Please also add the PCD File number to the cover page, which is "PPR-21-030".

**SUBJECT: Town of Monument Water Tank Site – Drainage Plan
744 Forest View Way
Monument, Colorado, 80132**

TANK SITE DRAINAGE PLAN
SCALE: 1"= 20'

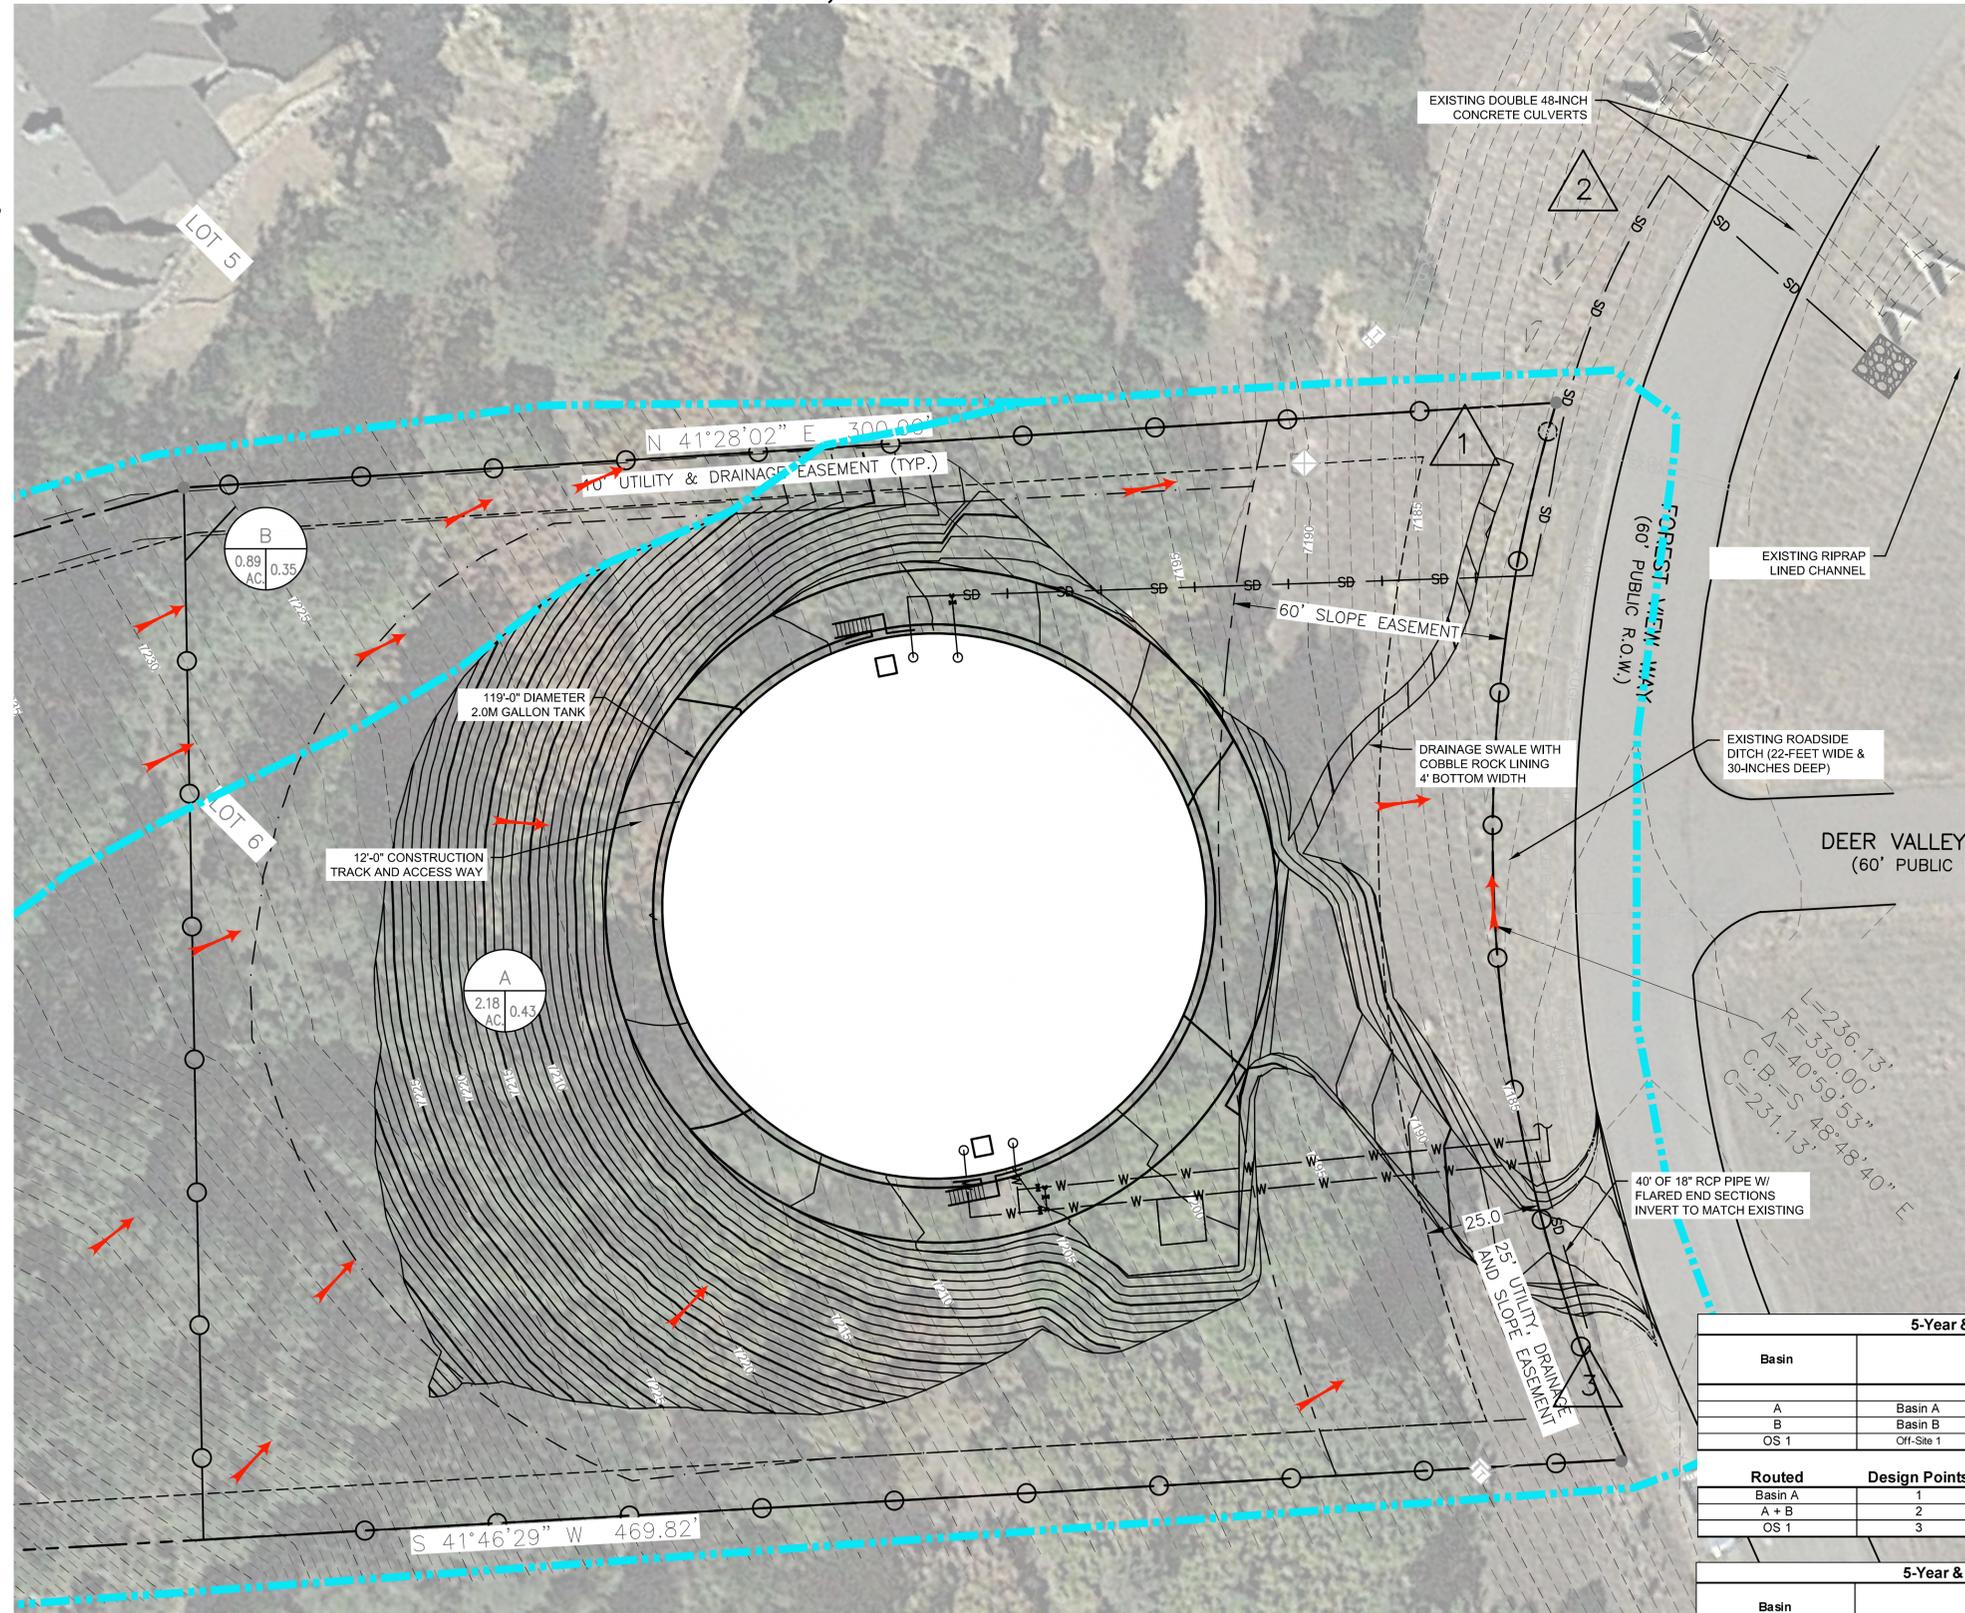
Please create a basic overview map with color shading/hatching that shows areas tributary to each PBMP (pond, runoff reduction, etc) and those areas that are not captured by the ponds, with the applicable exclusion labeled (ex: 20% up to 1ac of development can be excluded per ECM App I.7.1.C.1 and exclusions listed in ECM App I.7.1.B.#).

And specific to Runoff Reduction, this aforementioned map, or a separate one should show the UIA and SPA areas.

Please move drainage map to end of report contents.

Please include an existing conditions drainage map placed before the proposed conditions drainage map.

Please update map to show subbasins that drain to each design point.

PANEL 0257G

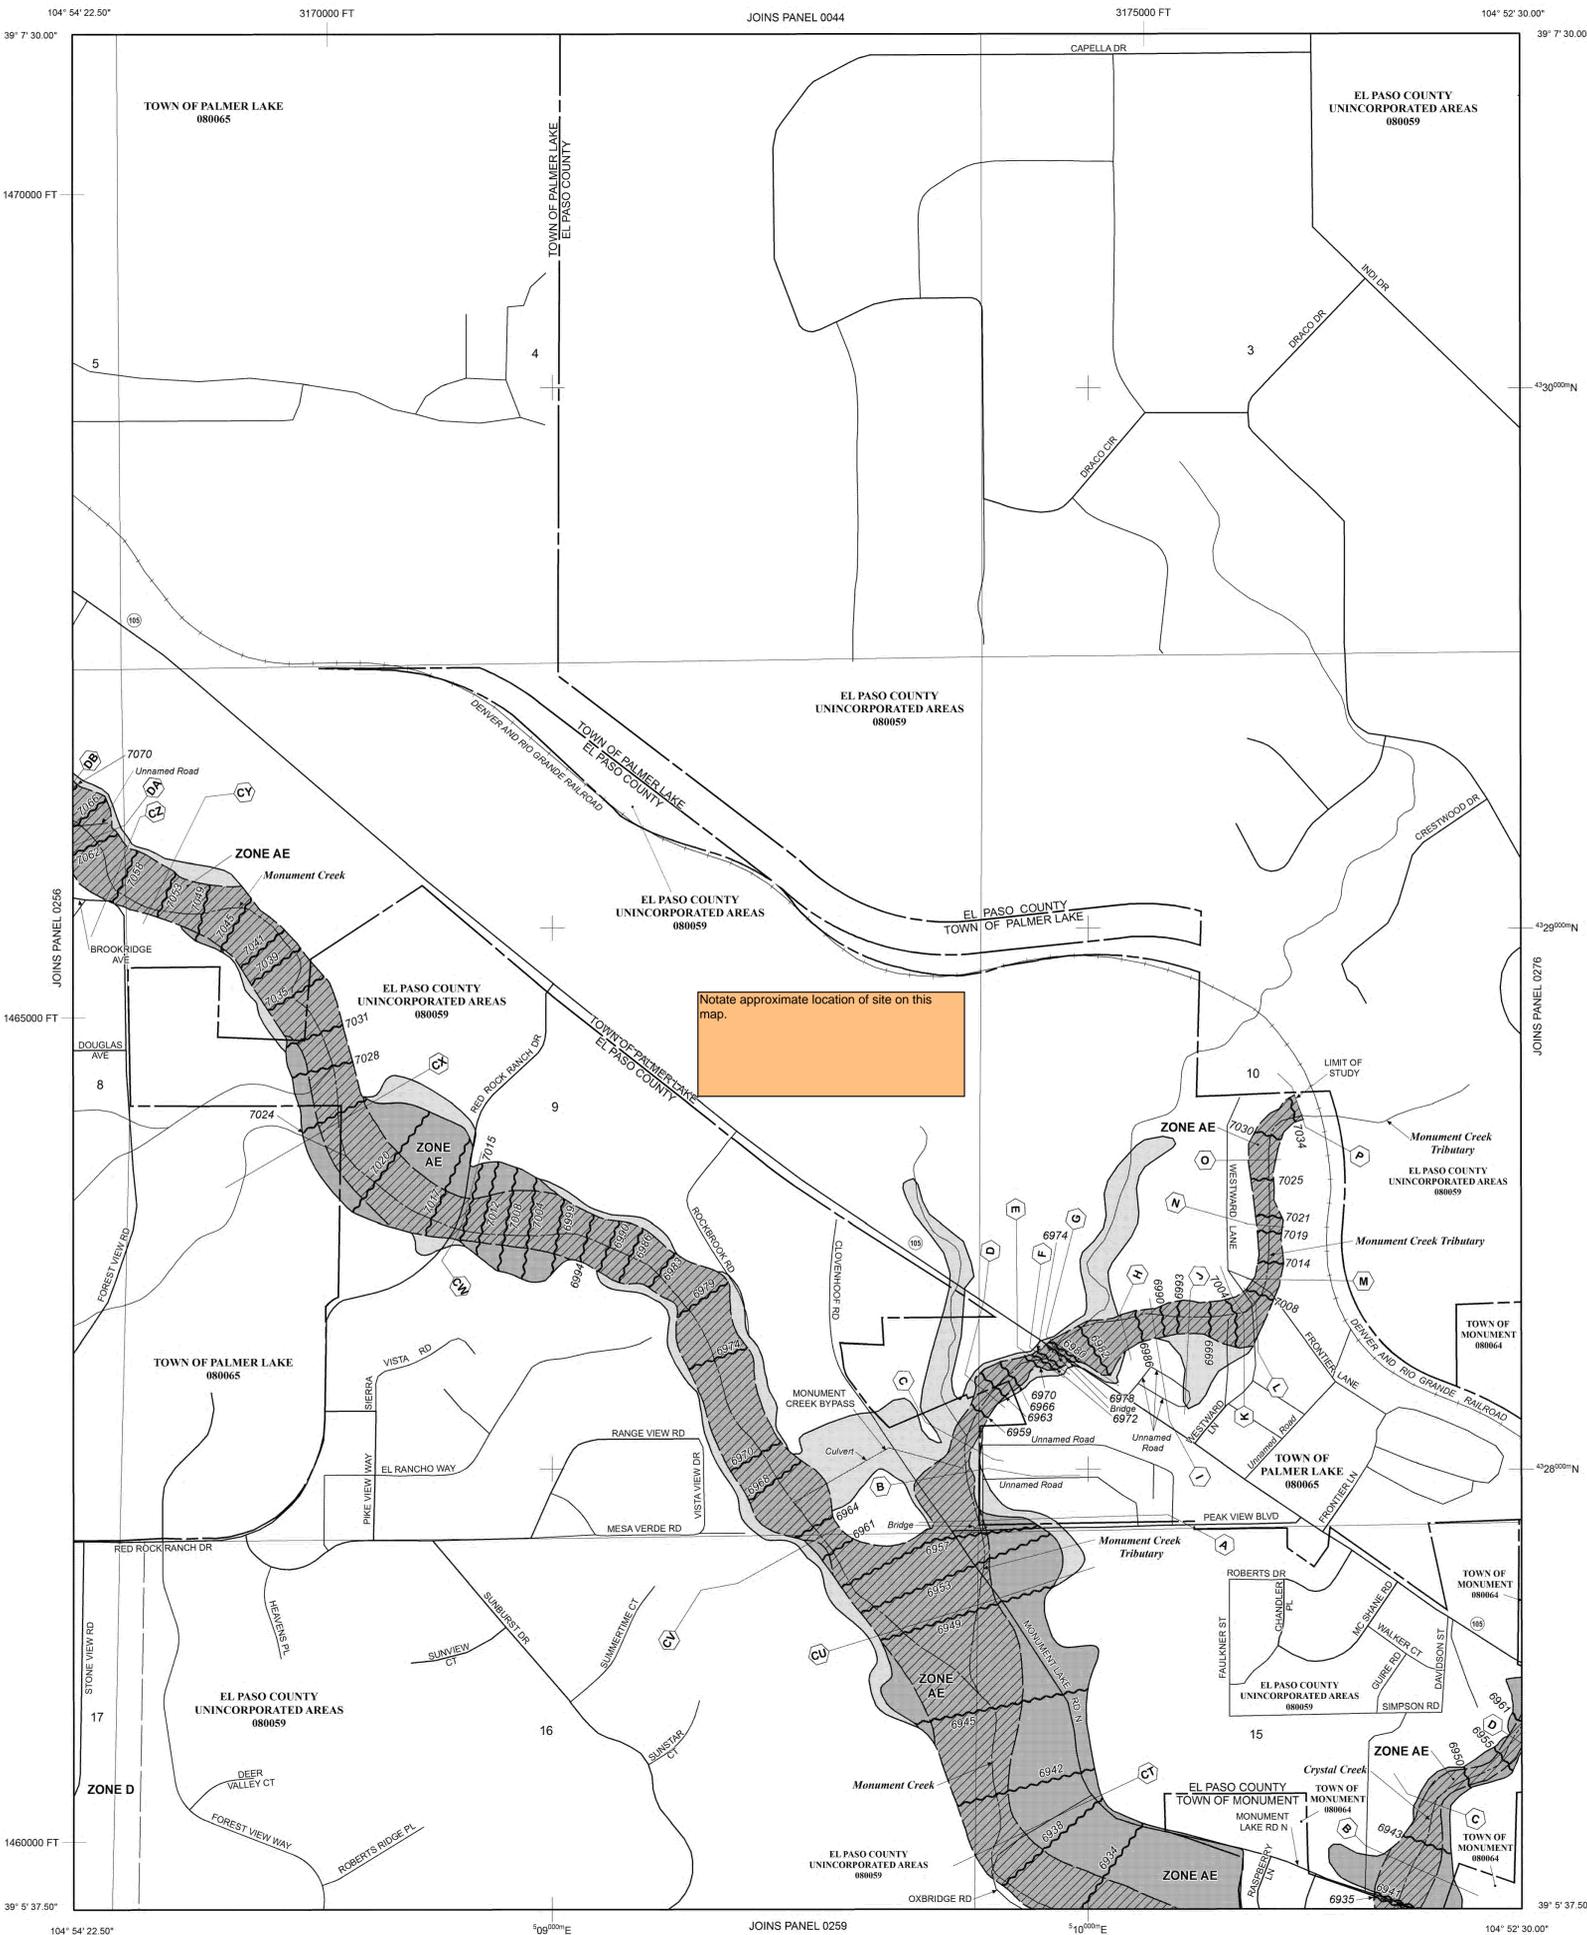
Notate approximate location of site on this map.
